## MHBU-100

### Profile change Notification

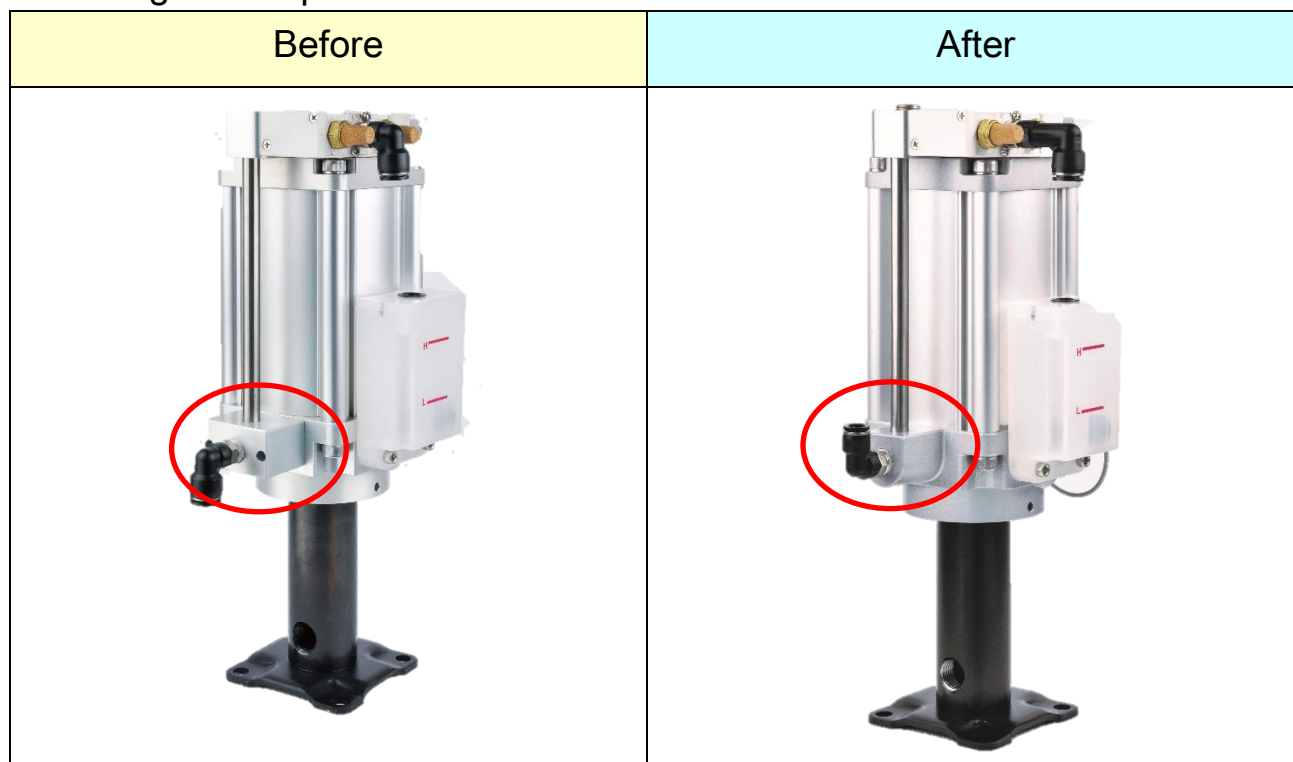
Change the profile to a smoother shape.

It will not affect usage and will be replaced sequentially.
